Reference Glider model GLASFLÜGEL " K E S T R E L " (17m)
German Data Sheet No. 276
Serial- No. affected: 25 through 129

Subject Dive brake control system in both wings

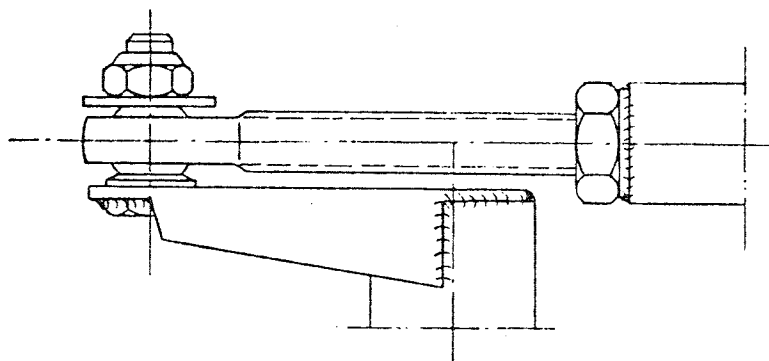
Reason Failure of a dive brake control rod end in the welded area caused operational problems

Method Welded control rod ends as per drawing No. 201-56-22 linked to the dive brake bevel gear must be replaced by new machine lathed rod ends according to drawing No. 401-56-23

Remarks Replacement of control rod ends is easily accomplished through rear root rib access holes. New rod ends are installed according to the sketch below:

By adjusting the rod end length the locking force should be adjusted so that the over-centering moment at the bevel gear actuator head does not substantially exceed 1 da Nm. In order to measure this moment the fuselage dive brake actuator tube may be removed temporarily and used for this purpose.
